# Access Compliance Report

## Public Rights-of-Way

### (Island Curb Cuts)

Intersection ID: 52767	Main Street: OUTLETS_BV	Cross Street: NEW_FASHION_WY	Location: SW
ADA ID: B2448D2DC7B5	Curb Cut Type: MedianRefuge2	Initial Pass/Fail: Fail	Overall Compliance: No
Codes/Mitigation Info/Possible Solution		Field Measurements/Component Compliance	
Severity Score: 0

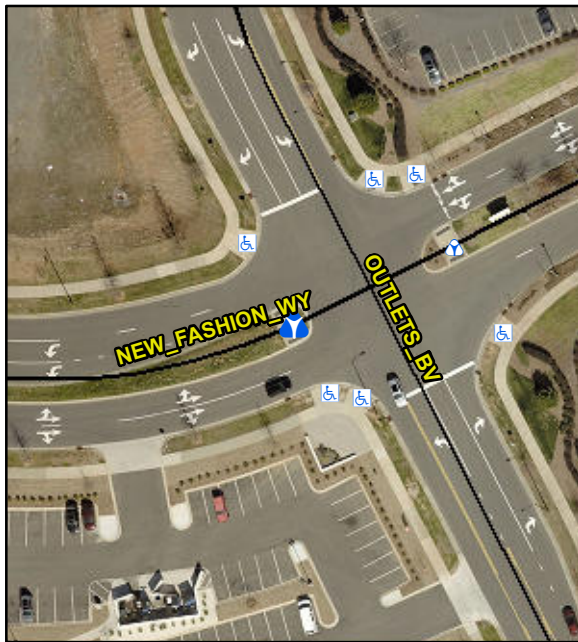
Compliance	Description	Data	Compliance	Description	Data
Yes	Refuge 1 Length (In)	115.0	N/A	Gutter 1 Ponding?	N/A
Yes	Refuge 1 Width (In)	114.0	N/A	Gutter 1 Lip Ht (In)	N/A
Yes	Refuge 1 Slope (%)	0.5	N/A	Gutter 1 Slope (%)	N/A
Yes	Refuge 1 X Slope (%)	2.6	N/A	Gutter 1 X Slope (%)	N/A
N/A	Painted X Walk1?	No	N/A	DWS 1 Provided?	N/A
N/A	X Walk 1 Direction	To SE	N/A	DWS 1 Contrast?	N/A
N/A	X Walk 1 Width (In)	N/A	N/A	DWS 1 Length (In)	N/A
N/A	Road 1 Slope (%)	2.9	N/A	DWS 1 Full Width?	N/A
N/A	Road 1 X Slope (%)	3.5	N/A	DWS 1 Offset (In)	N/A
Yes	Refuge 2 Length (In)	115.0	N/A	Gutter 2 Ponding?	N/A
Yes	Refuge 2 Width (In)	114.0	N/A	Gutter 2 Lip Ht (In)	N/A
Yes	Refuge 2 Slope (%)	1.9	N/A	Gutter 2 Slope (%)	N/A
Yes	Refuge 2 X Slope (%)	3.9	N/A	Gutter 2 X Slope (%)	N/A
N/A	Painted X Walk2?	No	N/A	DWS 2 Provided?	N/A
N/A	X Walk 2 Direction	To NW	N/A	DWS 2 Contrast?	N/A
N/A	X Walk 2 Width (In)	N/A	N/A	DWS 2 Length (In)	N/A

N/A	Road 2 Slope (%)	3.9	N/A	DWS 2 Full Width?	N/A
N/A	Road 2 X Slope (%)	2.7	N/A	DWS 2 Offset (In)	N/A
N/A	Refuge 3 Length (in)	N/A	N/A	Gutter 3 Ponding?	N/A
N/A	Refuge 3 Width (in)	N/A	N/A	Gutter 3 Lip Ht (in)	N/A
N/A	Refuge 3 Slope (%)	N/A	N/A	Gutter 3 Slope (%)	N/A
N/A	Refuge 3 XSlope (%)	N/A	N/A	Gutter 3 XSlope (%)	N/A
N/A	Painted X Walk3?	N/A	N/A	DWS 3 Provided?	N/A
N/A	X Walk 3 Direction	N/A	N/A	DWS 3 Contrast?	N/A
N/A	X Walk 3 Width (in)	N/A	N/A	DWS 3 Length (in)	N/A
N/A	Road 3 Slope (%)	N/A	N/A	DWS 3 Full Width?	N/A
N/A	Road 3 XSlope (%)	N/A	N/A	DWS 3 Offset (in)	N/A
Yes	Any Obstructions?	N/A	N/A	Storm Grate/Utility Hazard?	N/A
N/A	Obstruction Type		N/A	Storm Grate/Utility Type	
		N/A			N/A
N/A	Surface Condition	Good

**Remove & Replace Entire Refuge.**
